# Technical Service Bulletin

## 21 MIL on (DTC P0299 - negative pressure deviation); turbocharger excessive wastegate play

21 14 18 2031245/7 June 6, 2014. Supersedes Technical Service Bulletin Group 21 number 13-16 dated July 9, 2013 for reasons listed below.

**Figure 2.** Fit the clip from the side.

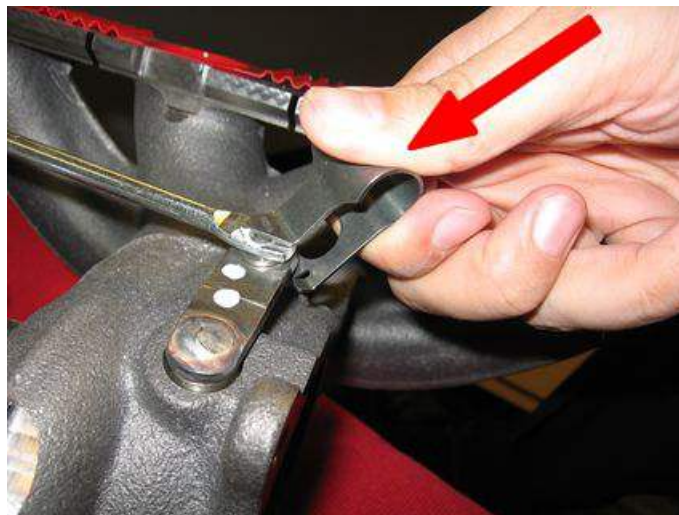
2. Remove turbocharger according to the instructions in ElsaWeb: *Repair Manual >> Engine / Engine Mechanical >> 21 Turbocharger, G-Charger >> Removal and Installation >> Turbocharger.*
3. Install clip **06J145220B** on a new, replacement turbocharger's link plate and actuating rod joint as illustrated (Figures 2 and 3).

- The spring clip must not be overstretched. The maximum opening of the spring clip is 14 mm (Figure 4, 1).
- The spring clip must be replaced after every removal.

**Note:** Do not install clip on a used or pre-damaged turbocharger, as the same level of improvement as on a new part is not achieved.

**Figure 5.** Correctly-fitted clip.

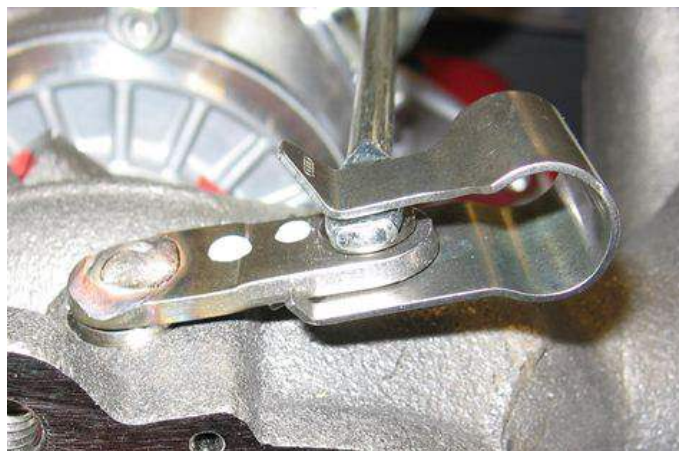
5. After fitting the spring clip, check for correct fit (Figure 5).

**Figure 6.** (1) Maximum opening of clip, (2) Position of original circlip

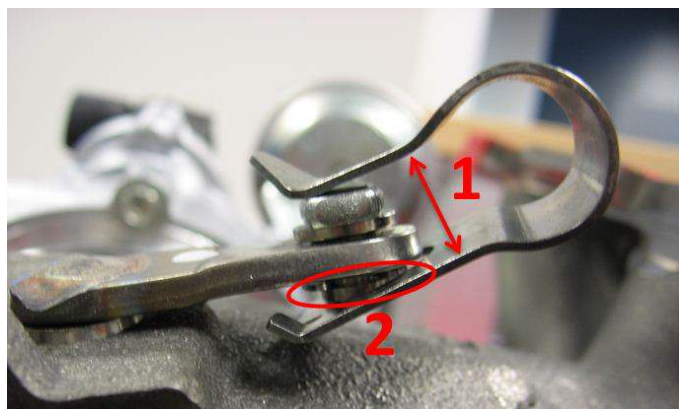
6. After fitting the spring clip, check the position of the original circlip (Figure 6, 2) and correct it if necessary.
